AGENDA
Design Review Committee
July 13, 2022 – REGULAR MEETING
5:00 PM

Town of Jackson Design Guidelines Checklist

Item Number: P22-120

Address: 295 W. Pearl Ave

SITE PLAN
 NTS

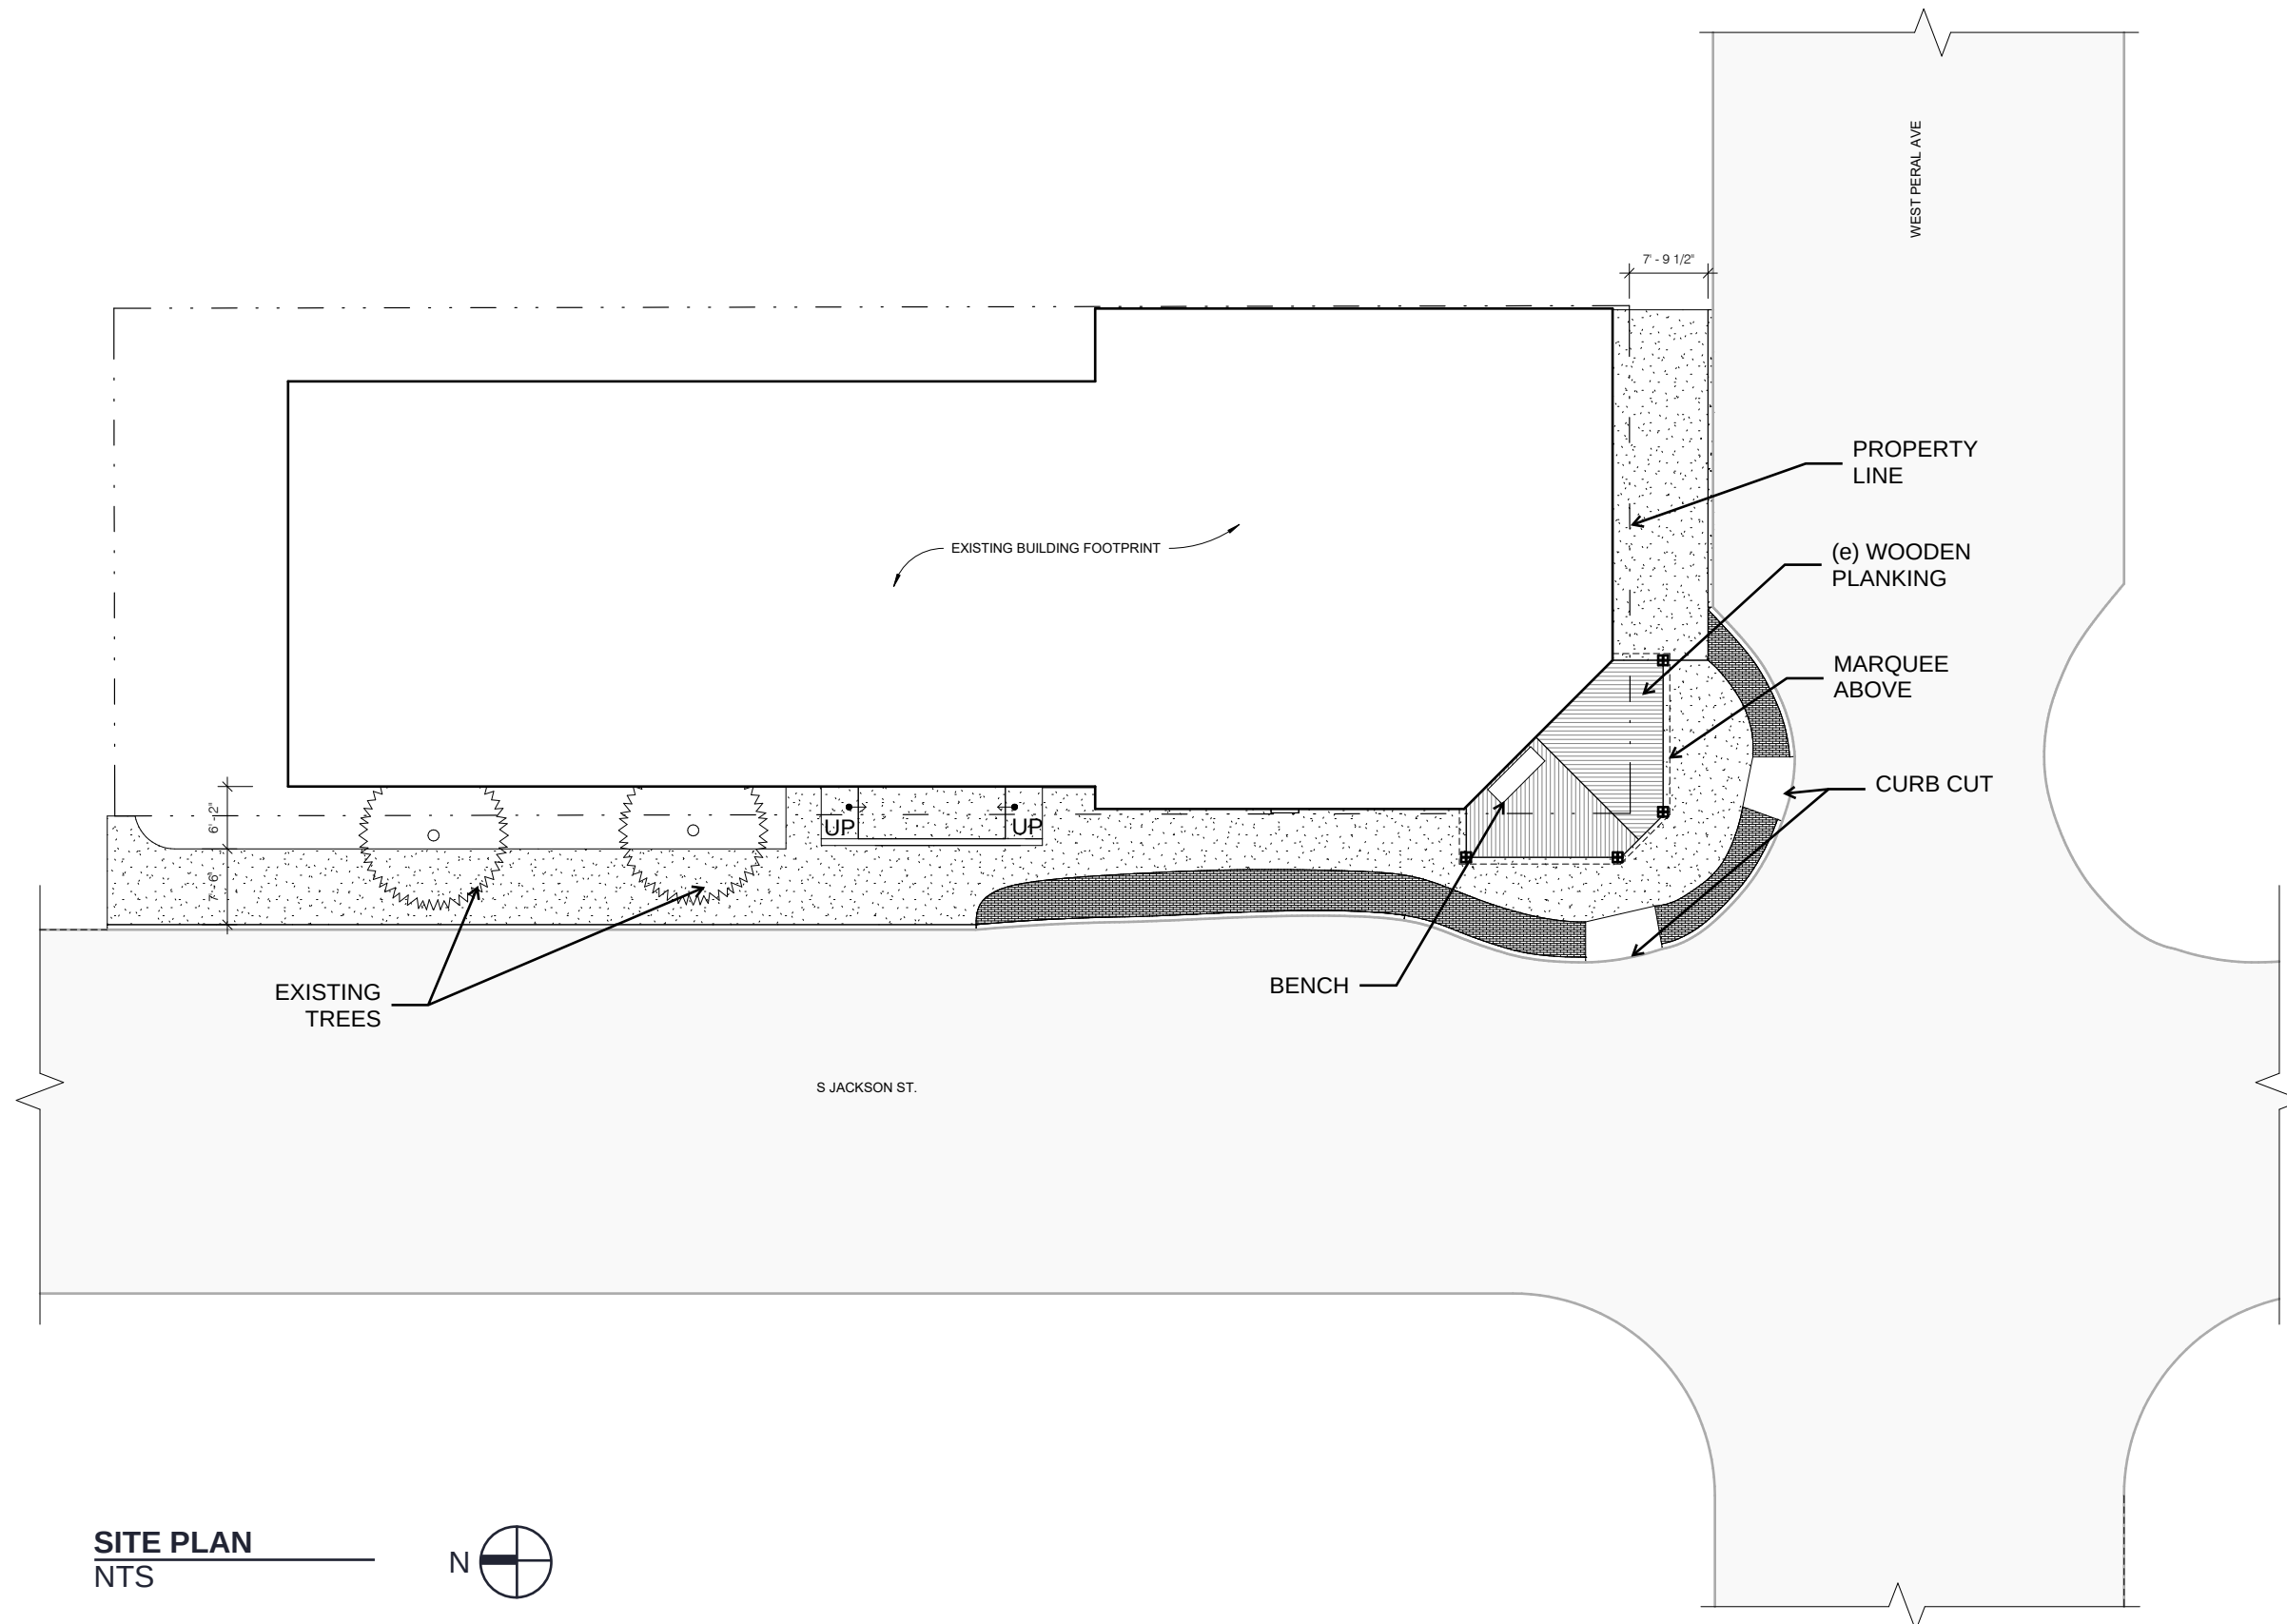
1. Include site plan with resubmission, specifically showing where the proposed design encroaches the Public Right of Way (PROW). Plan shall contain property lines, curbs, subtext.

- a. Applicant Response: Resubmittal provides site plan as requested, including showing the property line in relation to the building.
2. Include more detail for the wood material to understand how the cladding will look on the building and columns and particularly how the cladding will function in the high trafficked PROW area.

ELEVATION - EAST
NTS

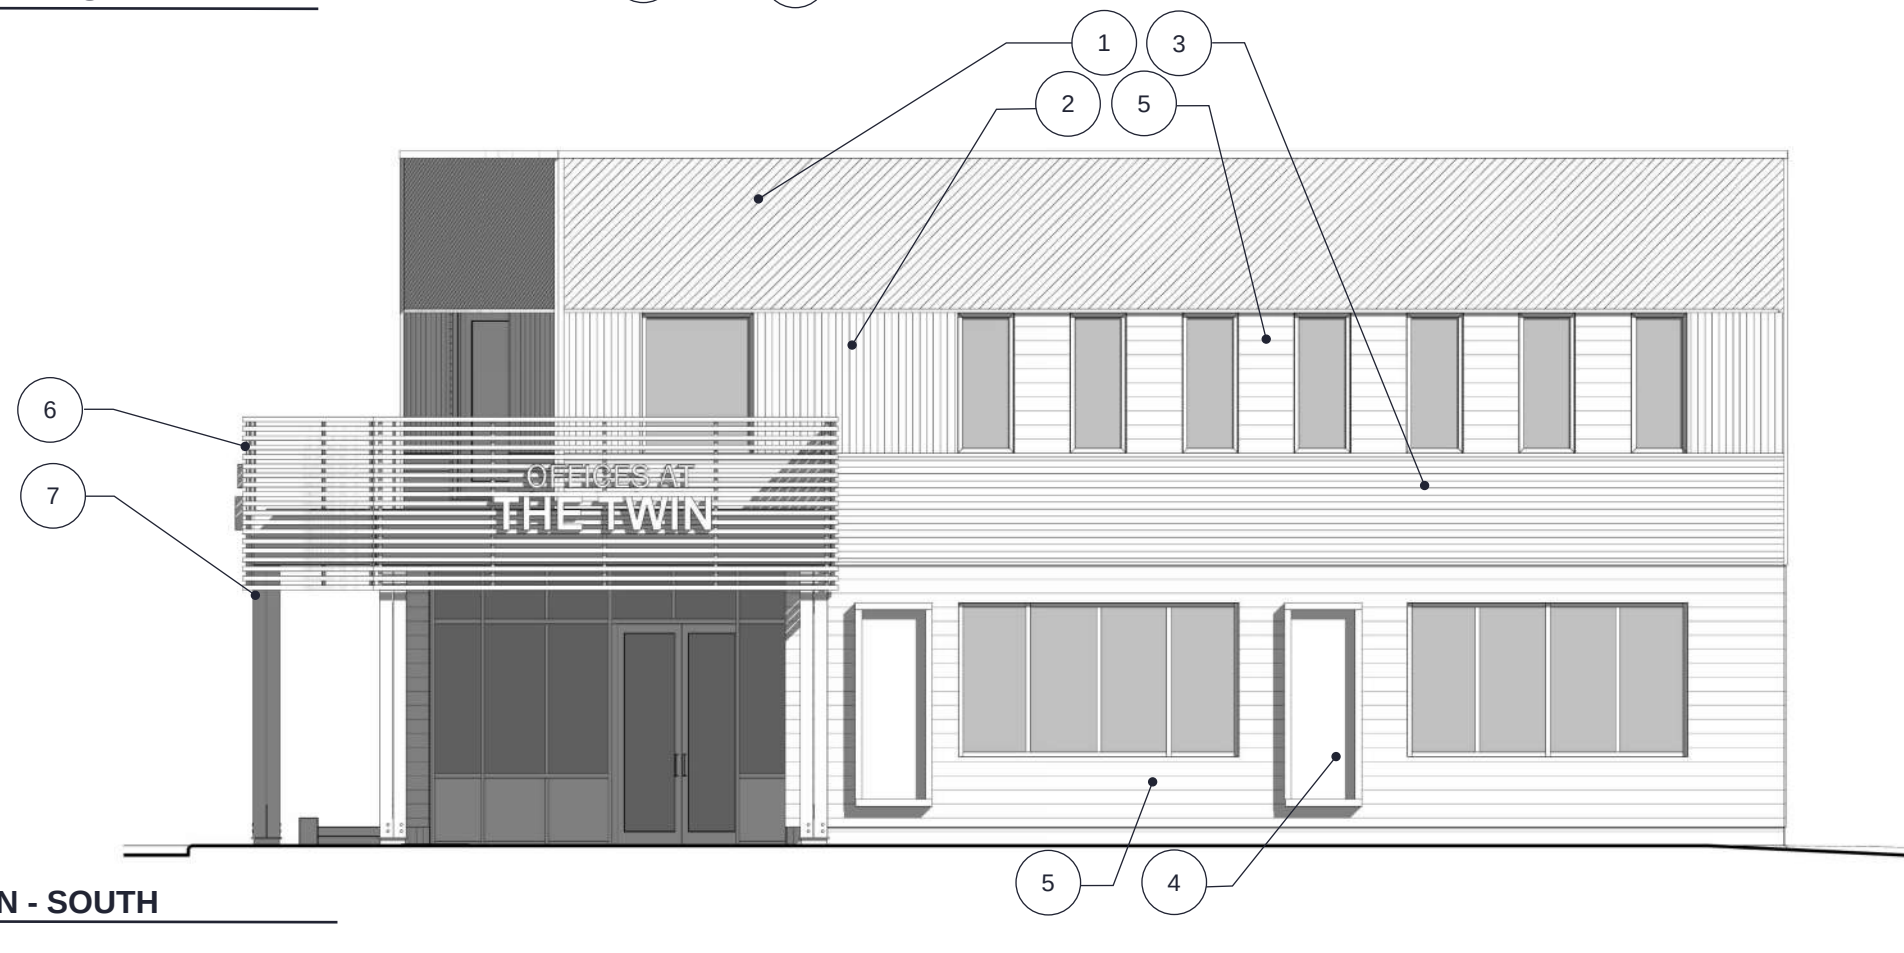
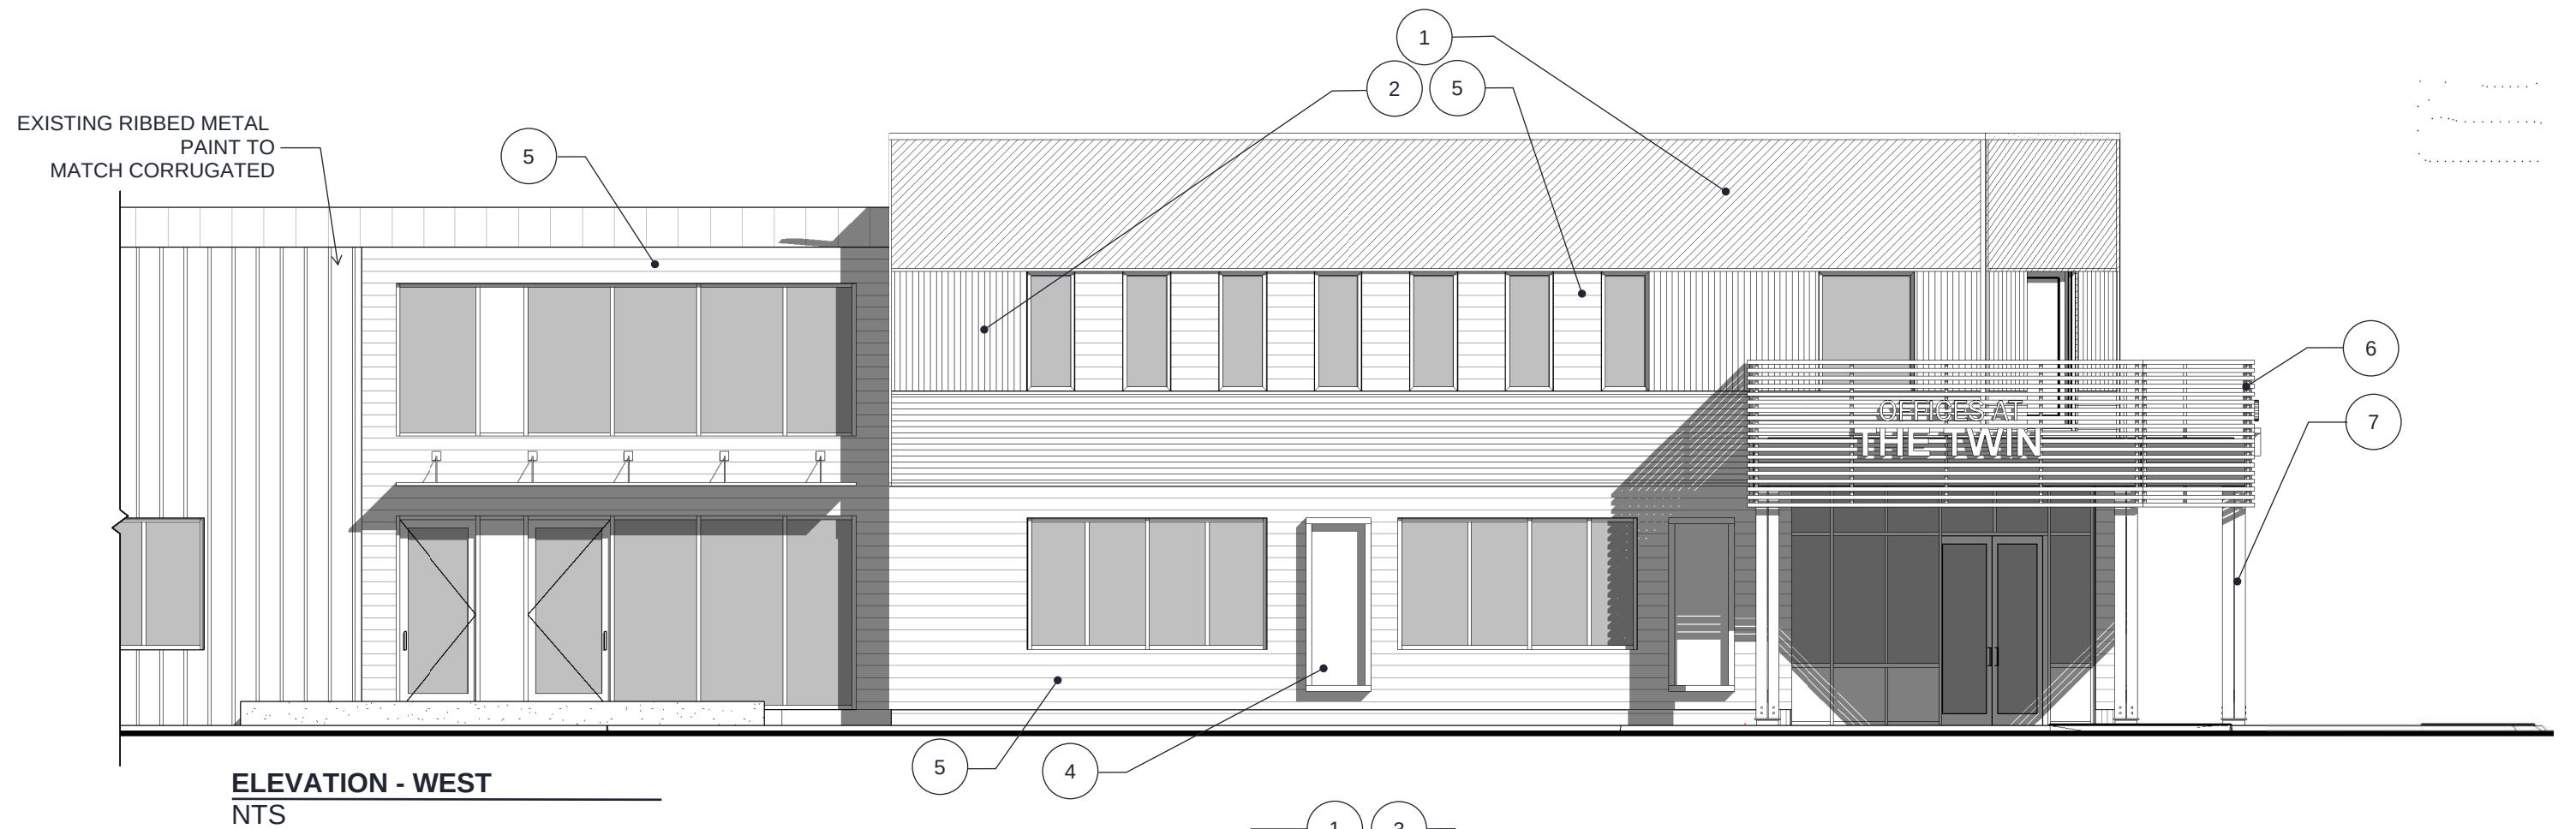
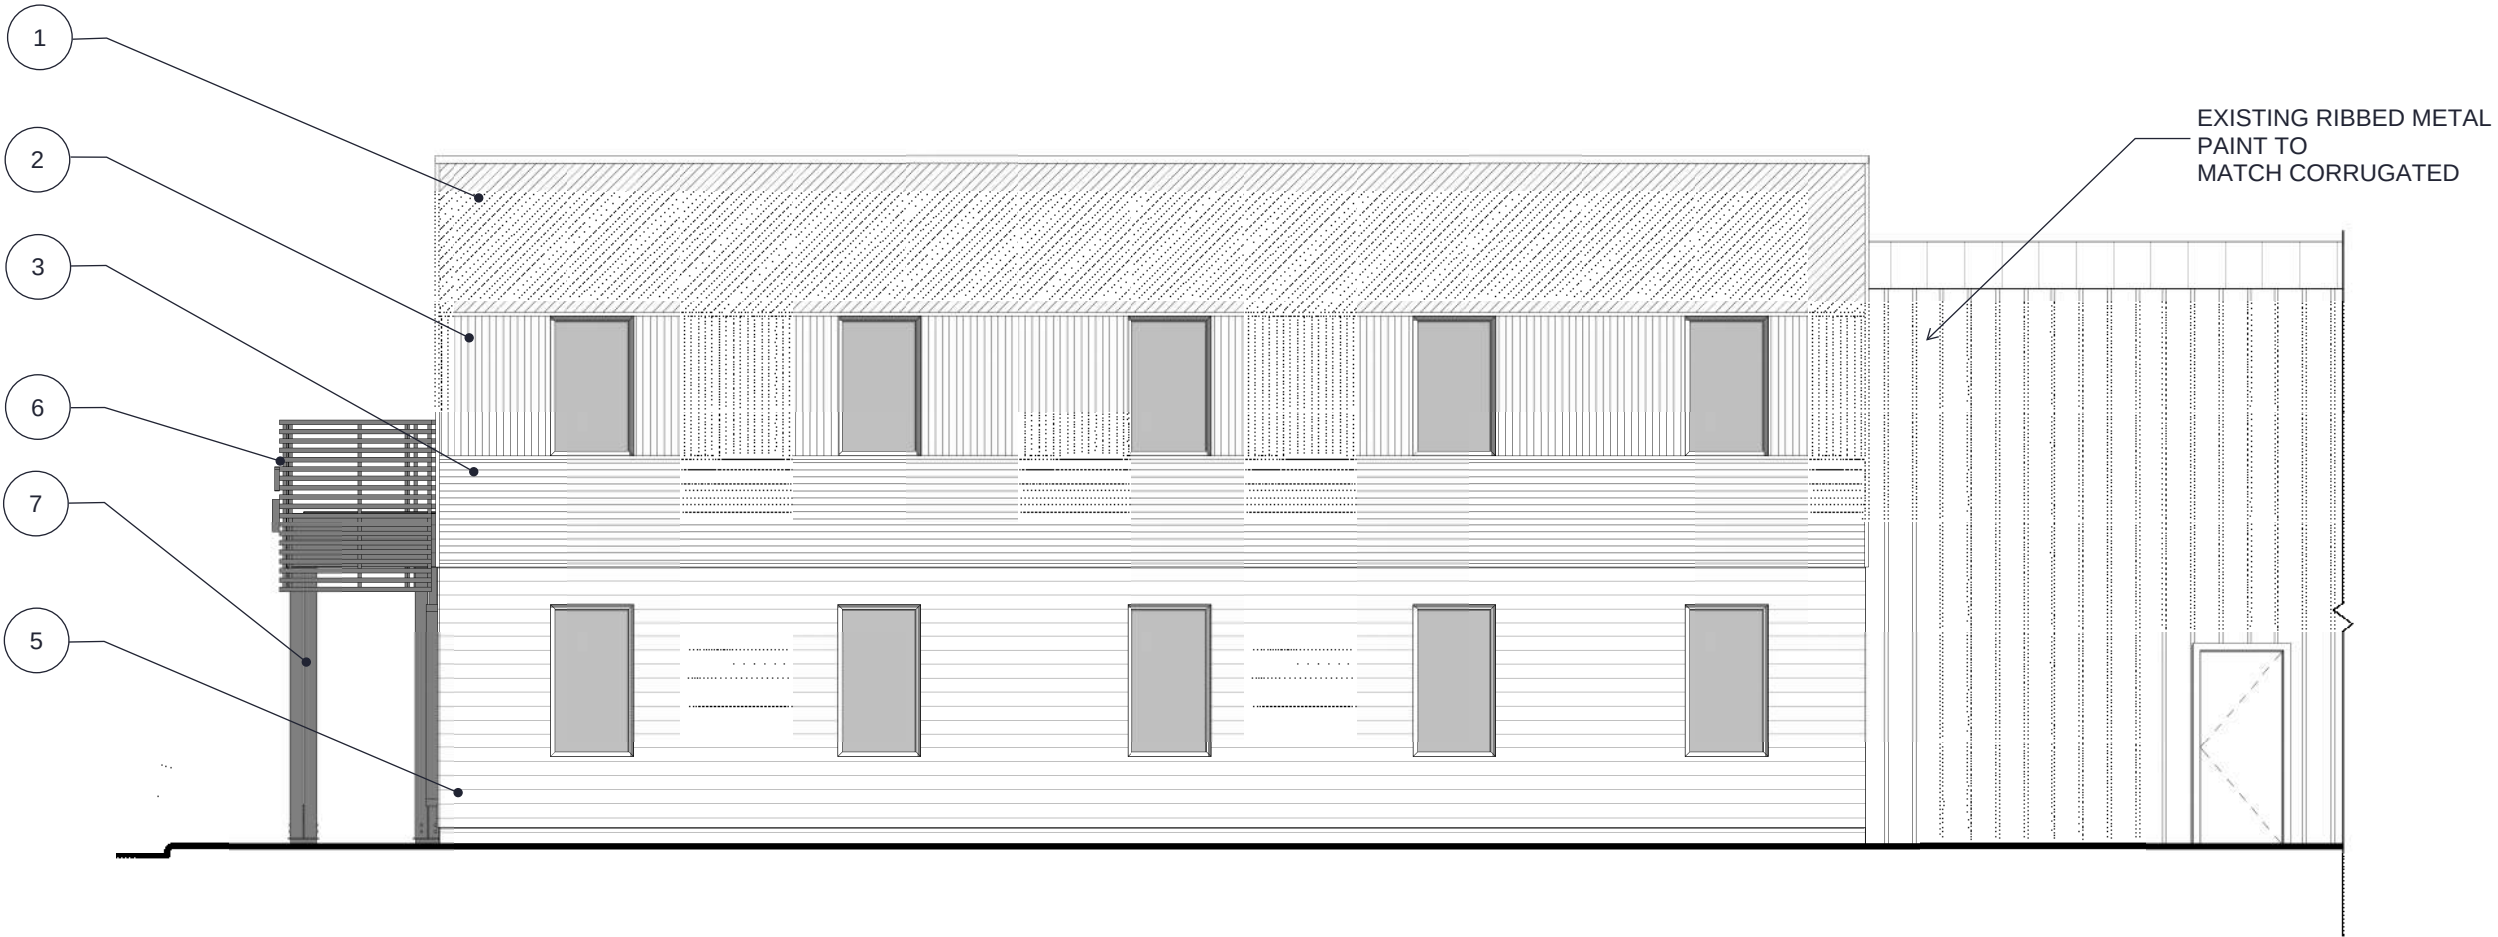
3. Red metal panel translates as too industrial an application, particularly in the downtown area and at the pedestrian level.
 - a. Applicant Response: Resubmittal shows that the first level exterior material has been changed from a red metal panel to a High Pressure Laminate (HPL) wood panel (sample available at the planning office). The existing columns for the canopy will be replaced with timber and stained to match the metal wood panel siding.

- a. Applicant Response: Resubmittal shows that wood panels on the second level have been changed to brushed gunmetal corrugated metal that will be oriented in vertical and diagonal patterns (sample available at the planning office).
